# 802.3ch Communication Link Access Latency – Table 78-4

# Wake latency issues with 802.3cy D2.1 – Comment #804

# Key equations and parameters

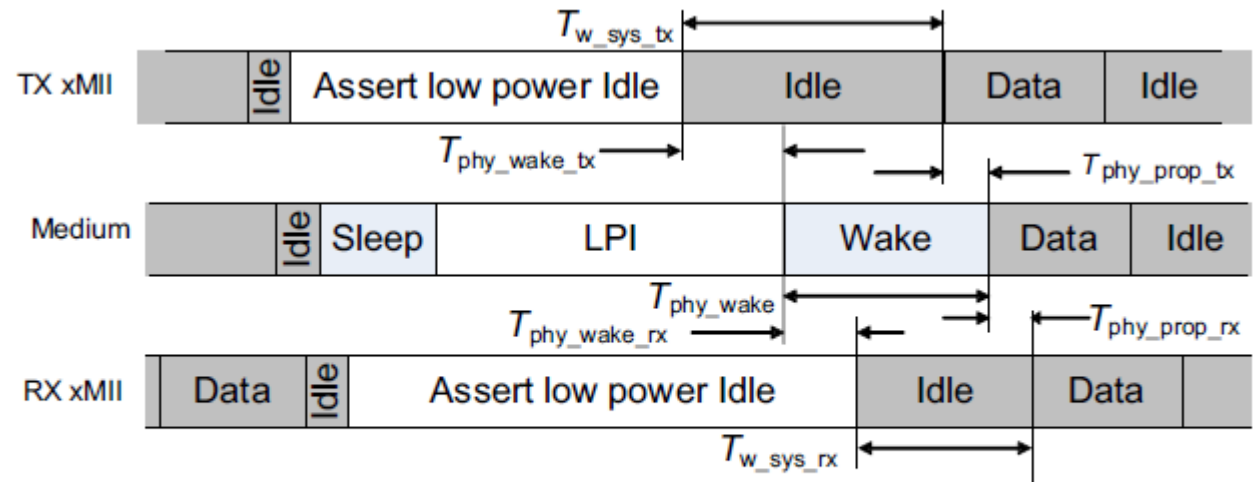
- $T_{w\_sys\_rx} = T_{phy\_wake}$  (already in D2.0)
- $T_{phy\_shrink\_rx} = 0$ . Received Wake length on the MDI is the same as the received length on the xMII.
- From Figure 78-5 – LPI timing parameters ...
  - $T_{w\_sys\_tx} = T_{w\_sys\_rx} + T_{phy\_shrink\_tx} + T_{phy\_shrink\_rx}$
  - $T_{w\_phy} = T_{phy\_wake} + T_{phy\_shrink\_tx}$
  - $T_{w\_sys\_tx} = T_{w\_phy}$

$$\begin{aligned} T_{w\_sys\_tx} (\text{min}) &= T_{w\_sys\_rx} (\text{min}) + T_{phy\_shrink\_tx} (\text{max}) + T_{phy\_shrink\_rx} (\text{max}) \\ T_{w\_phy} (\text{min}) &= T_{phy\_wake} (\text{min}) + T_{phy\_shrink\_tx} \end{aligned}$$

# Graphical measurement of Table 78-4 LPI timing parameters

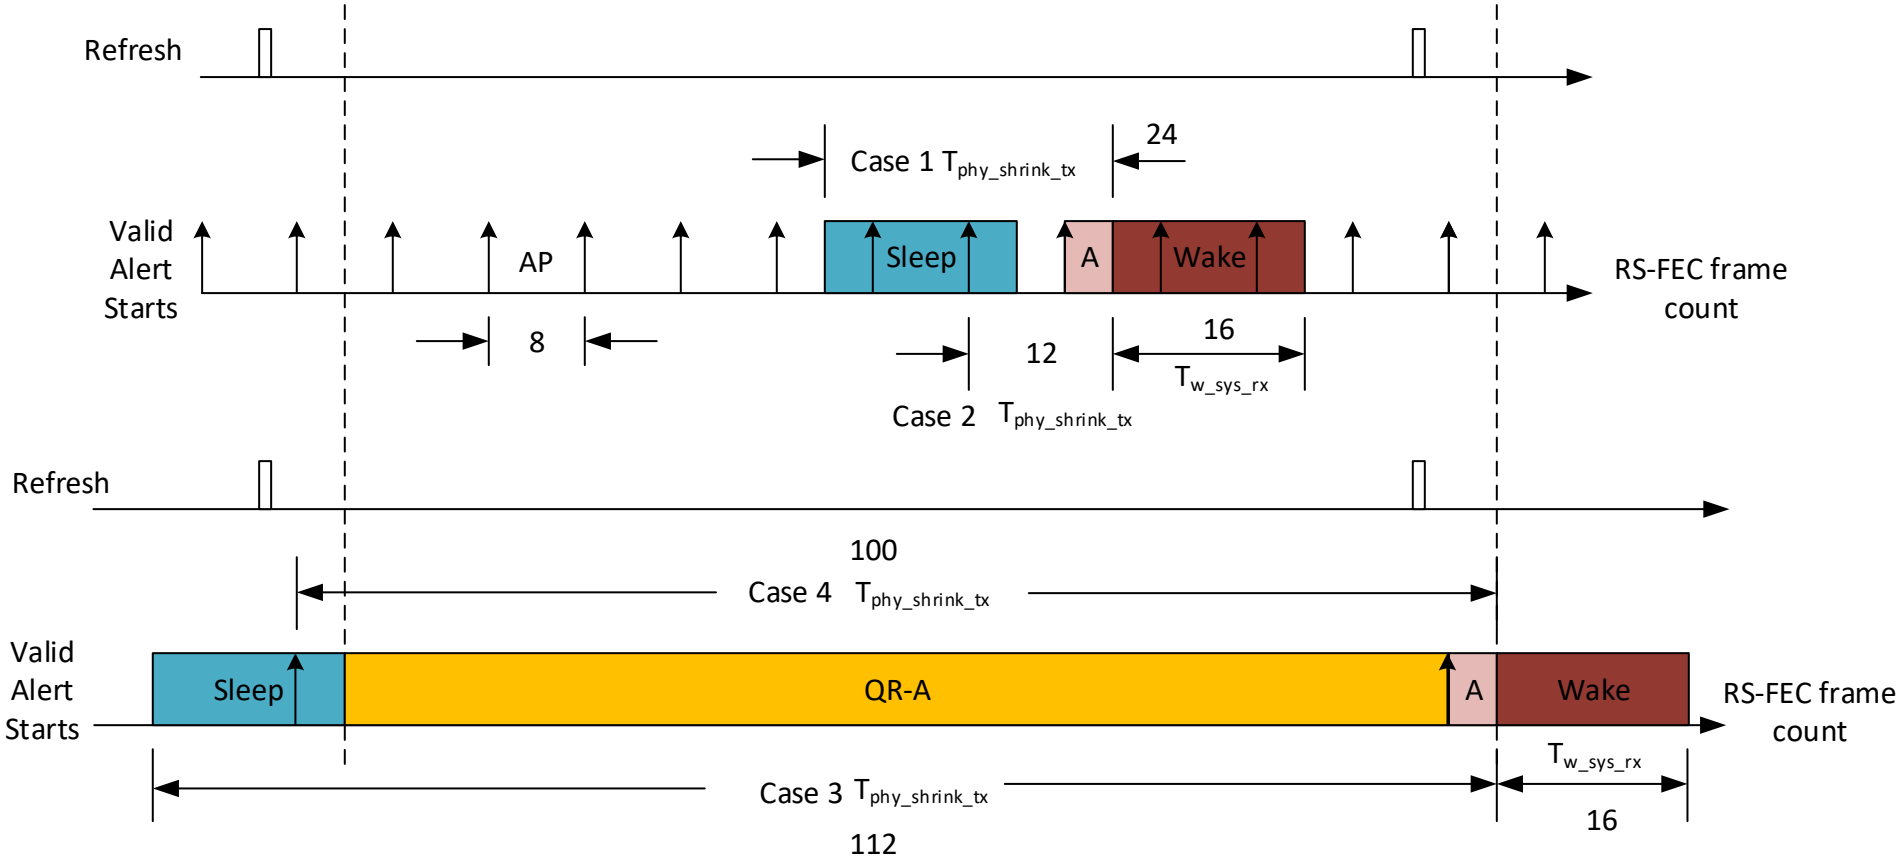
- Use Figures 165-11 and 165-12

<u>Latencies (us)</u>		Table 78-4				
Data Rate	Case	$T_{w\_sys\_tx}$	$T_{w\_phy}$	$T_{phy\_shrink\_tx}$	$T_{phy\_shrink\_rx}$	$T_{w\_sys\_rx}$
25 Gb/s	Case-1	13.31	13.31	7.987	0	5.325
25 Gb/s	Case-2	9.318	9.318	3.994	0	5.325
25 Gb/s	Case-3	42.60	42.60	37.27	0	5.325
25 Gb/s	Case-4	38.60	38.60	33.28	0	5.325
